Planning Application Number: 25/00990/FUL

Application Address: Land Off Station Road, Bagworth

Table 1: LCC Highways Response Tracker (June 2026)

Appendix 1 – LCC Highways Response dated 9th June 2026

Swept Path Assessment for Refuse Vehicle

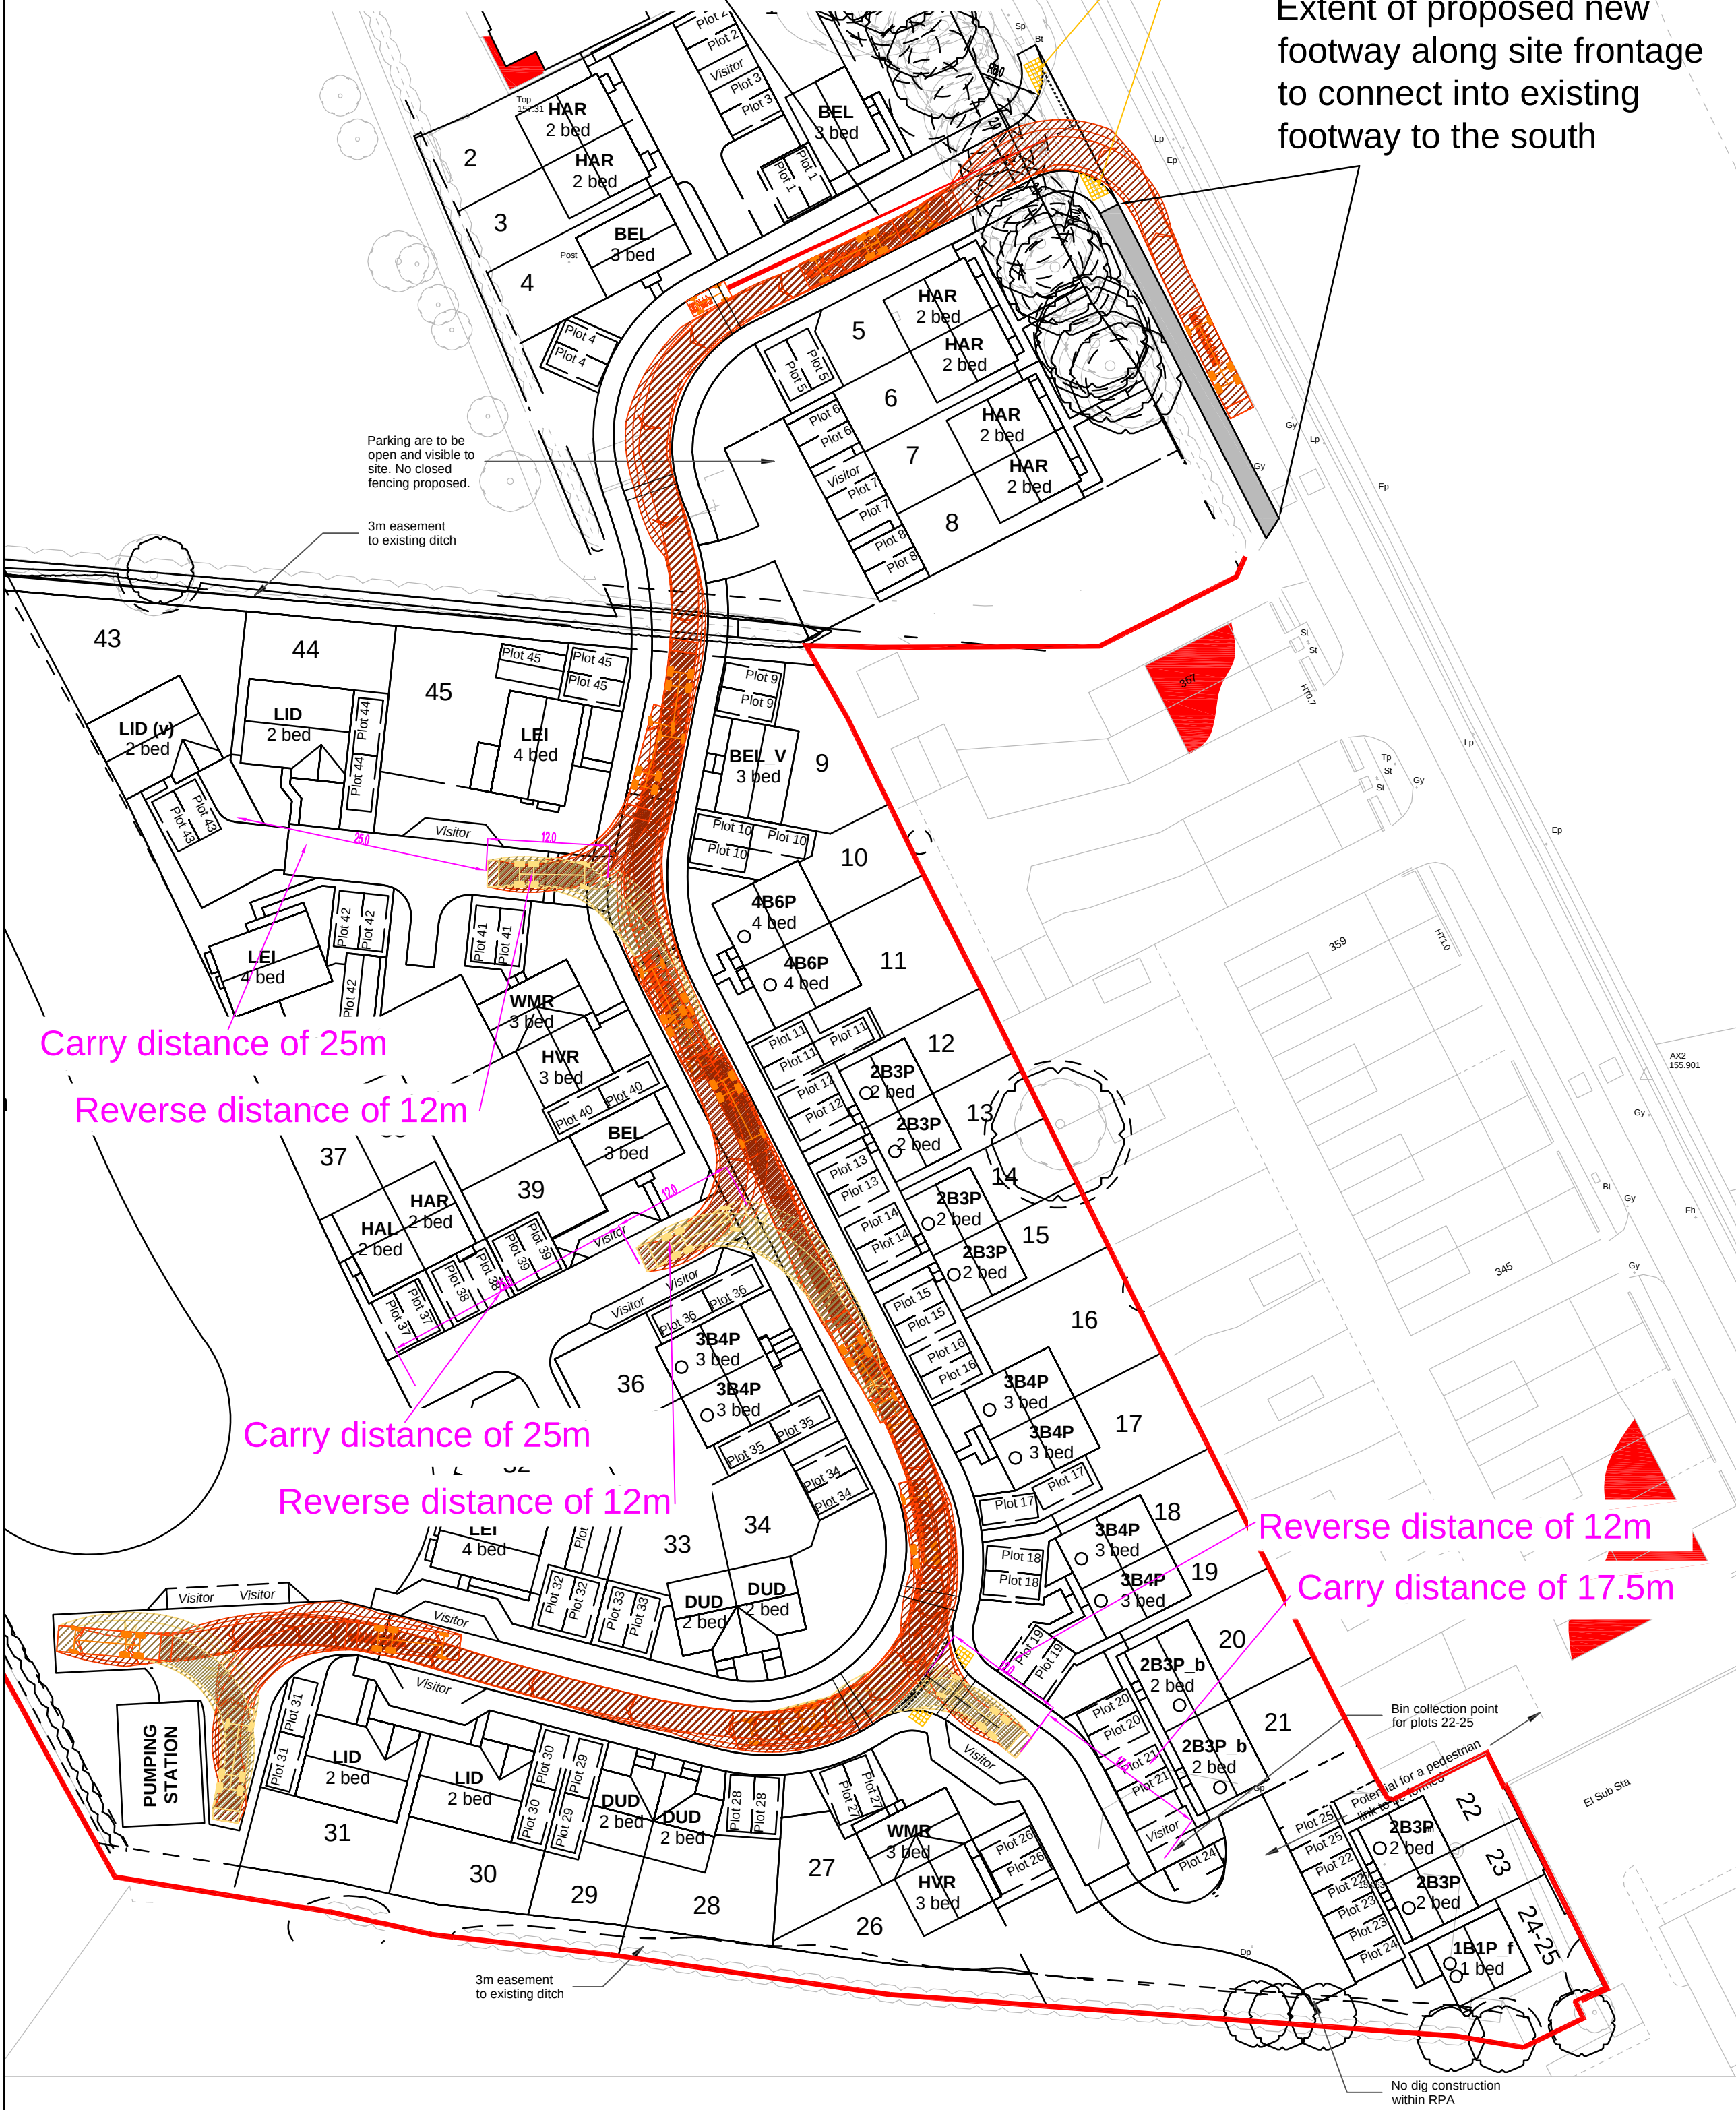
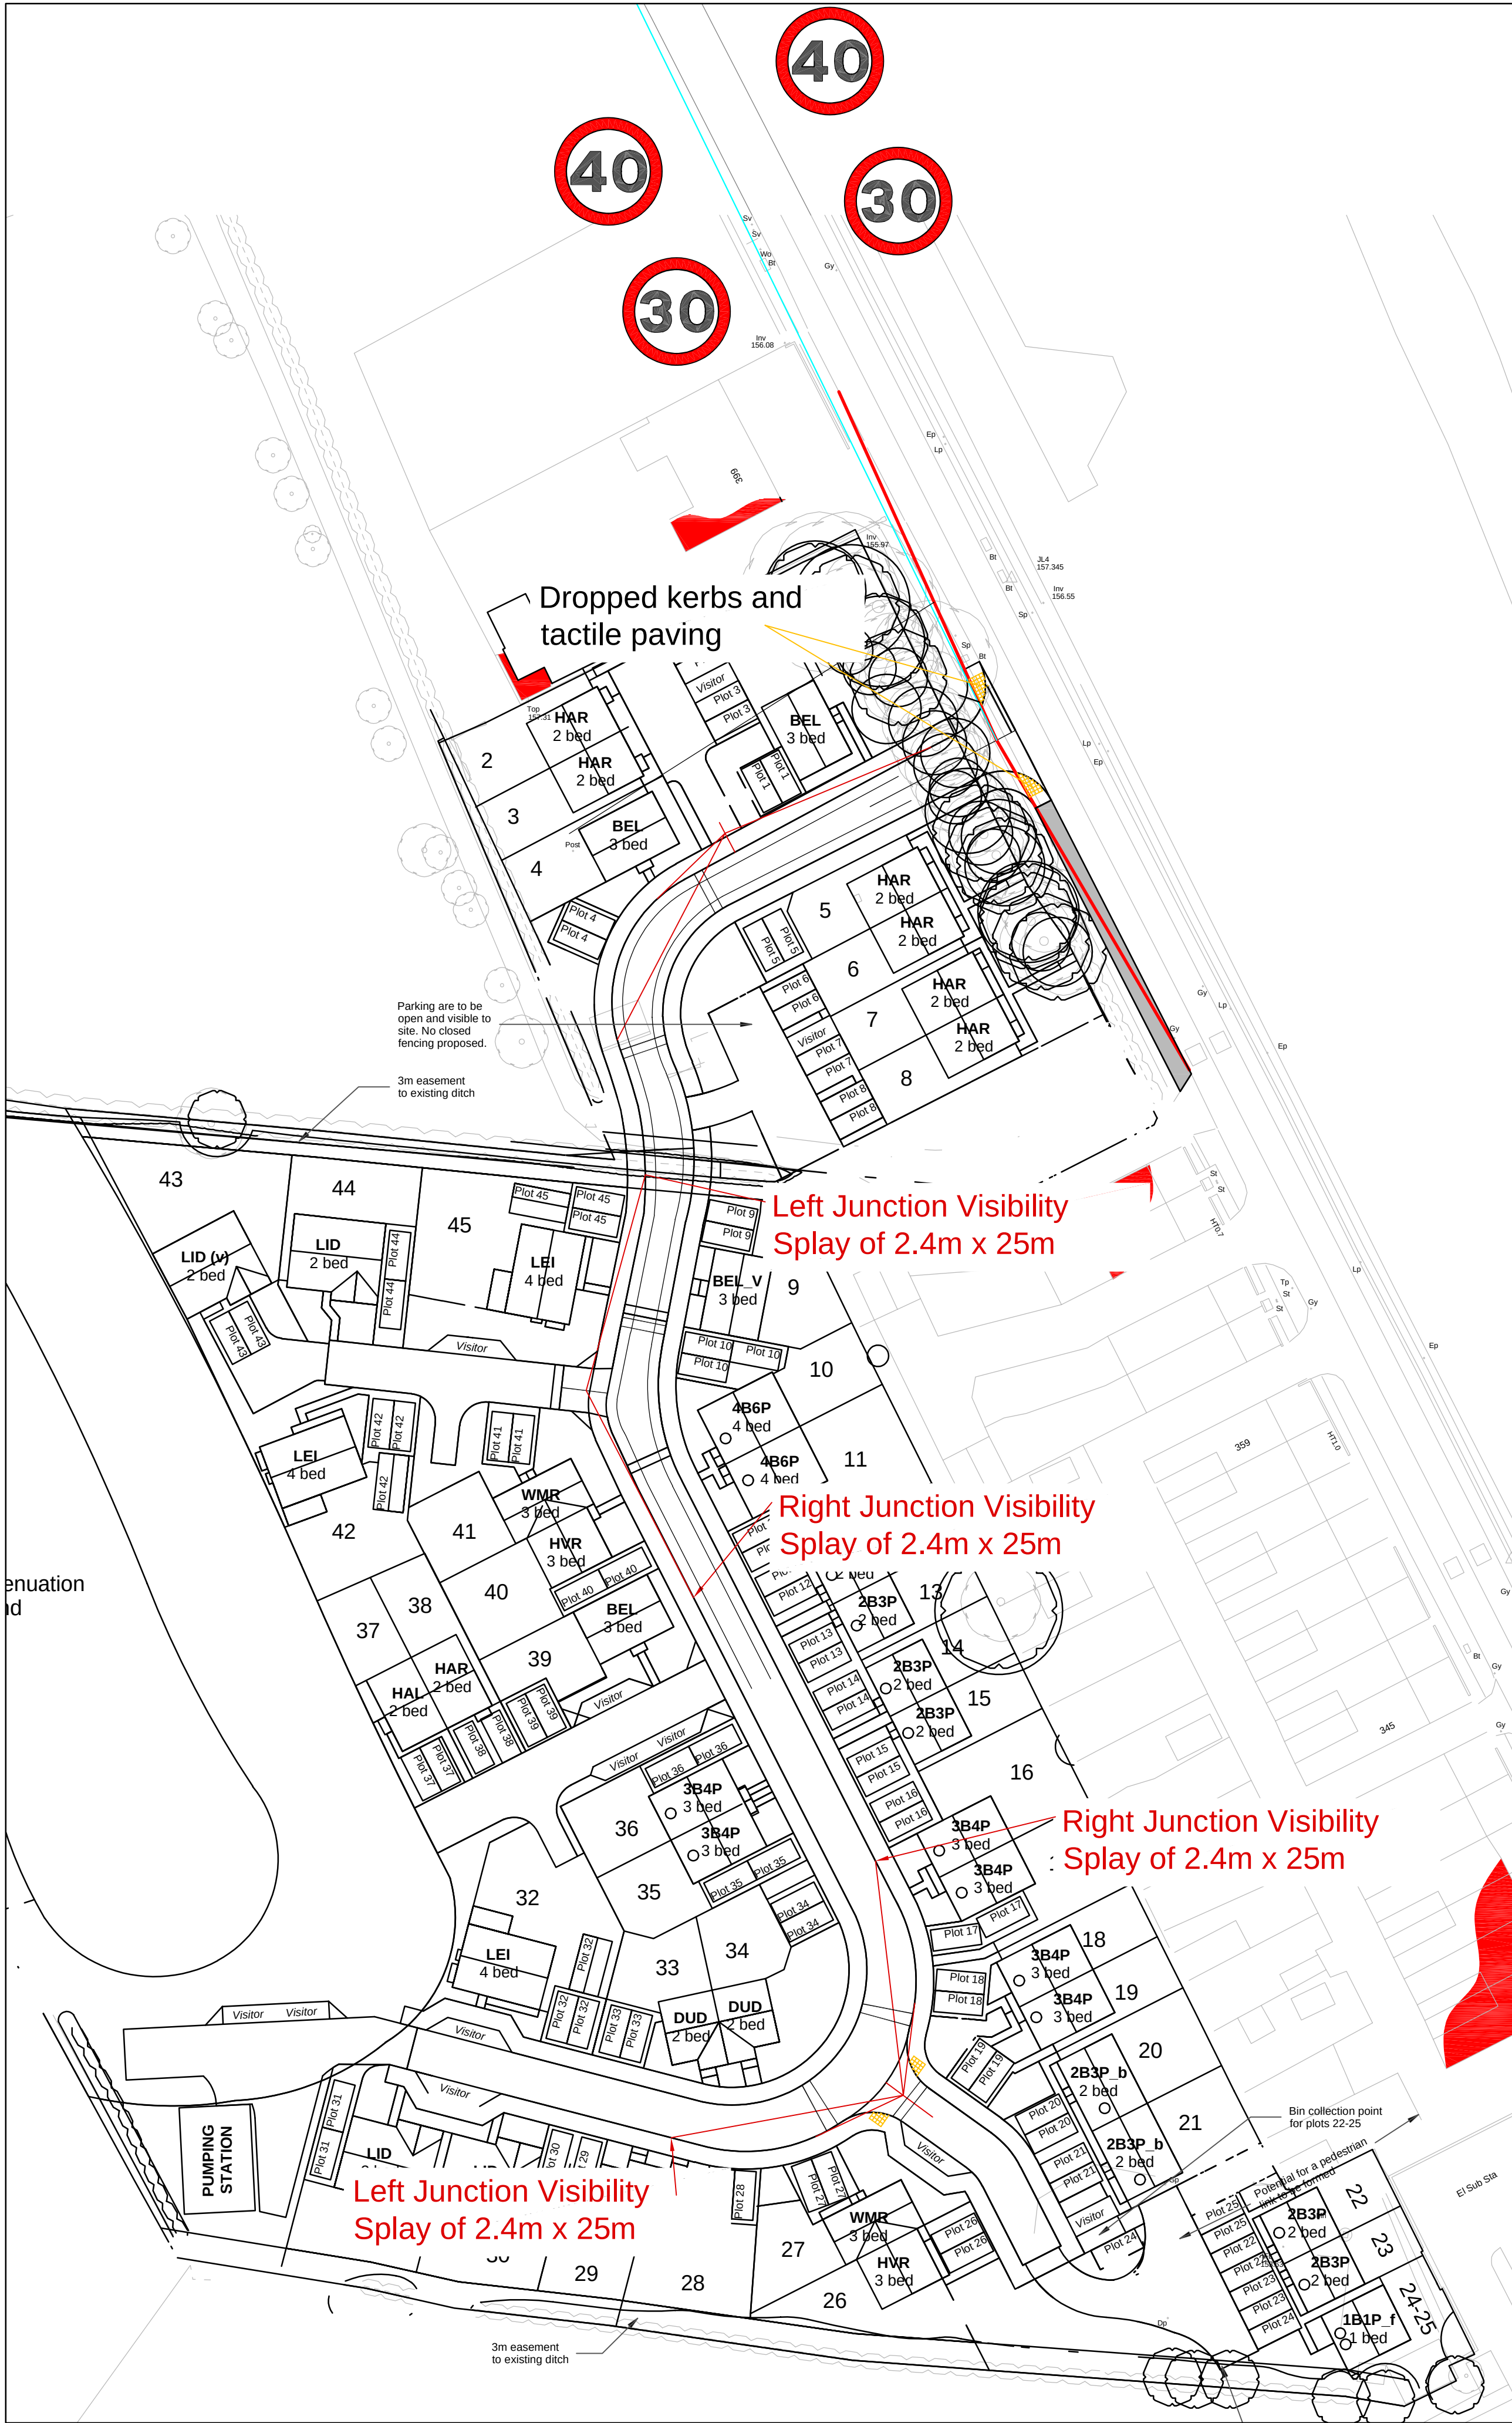
The Applicant should please provide refuse vehicle tracking of the site in accordance with the section of the LHDG titled '[Swept Path Analysis](#)'.

Minimum available intervisibility of 39m between a refuse vehicle seeking to enter the site and a vehicle approaching the give way line (leaving the site)

Dropped kerbs and tactile paving

Extent of proposed new footway along site frontage to connect into existing footway to the south
